**GLYNN COUNTY STADIUM
SITE WORK**

ADDENDUM NO. 4

DATE: May 3, 2018

CONT.	
JOB	
WINGWALL WITH FOOTING	
DATE	DRAWN BY
1/16	CLASSIC DESIGN
	DRAWING NO.
	9-3

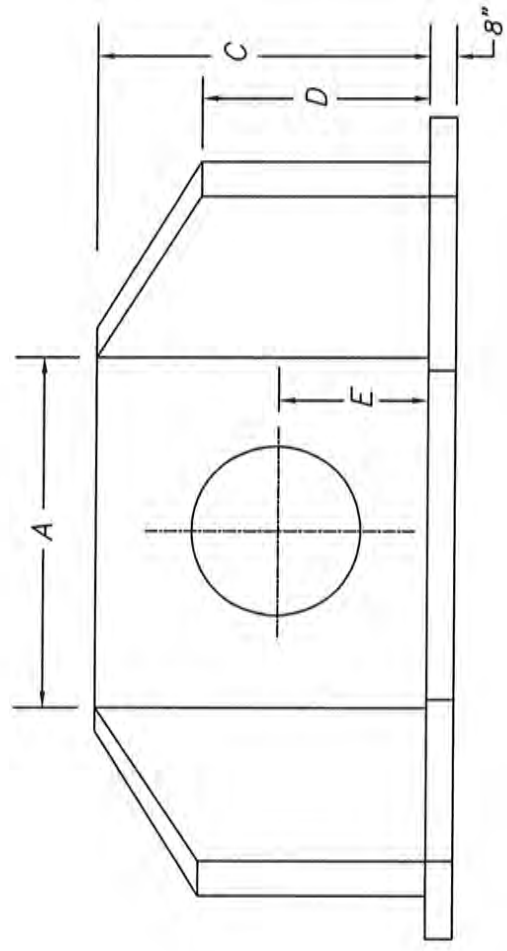
Alternate No. 3: Quote a 48” Pre-Cast Concrete headwall with a poured in place apron instead of the cast-in place headwall detail.

1. **Base Bid:** Cast-In place headwall detail.
2. **Alternate:** 48” Pre-Cast Concrete headwall with a poured in place apron.

- B. Attached is sketch of Wingwall with Footing. Quote can be by any Pre-Cast Manufacturer.

- NOTES :
- * ALL EXPOSED EDGES TO HAVE 1" BEVELED CORNERS
 - * APRON BY CONTRACTOR IN FIELD
 - * REINFORCING - NO. 4 BARS AT 12" O.C.E.W.
 - * CONCRETE TO TEST 4000 PSI @ 28 DAYS
